**From:** Helen Ellis-Caird  
**Sent:** 11 April 2023 08:10  
**To:** Jill Bastow  
**Subject:** Re: NYM/2023/0151 Shambala

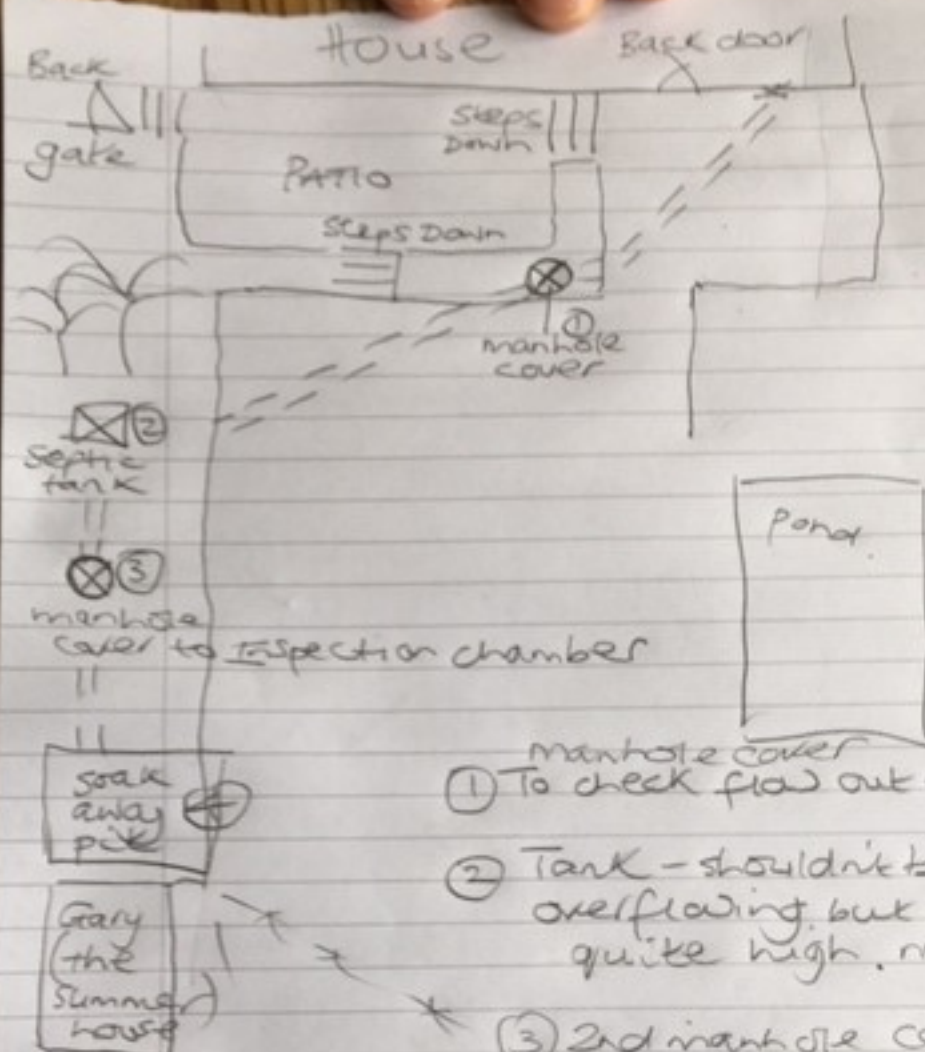
In terms of the ecologists questions below, I have addressed the points they raise below:

- I spoke to the previous owner of the property Jane Pinner, to see if I could find out more information about the septic tank, she told me that when they were resident between 2009 and 2017 they installed a new soak away for the septic tank, which complied with all legislation. She sent me the attached plan which shows where the soak away is located. I can therefore confirm that this complies with 2020 legislation and does not drain into a water course, and instead that a relatively new soak away is installed.

- manhole cover
- ① To check flow out of house
  - ② Tank - shouldn't be overflowing, but can be quite high, normally
  - ③ 2nd manhole cover, in direct line with tank To check flow out of the tank.
  - ④ Soak away somewhere between ③ + Gary NOT visible Buried deep + full of stones gravel etc.
  - ⑤ Unknown path of field drains. Very deep.
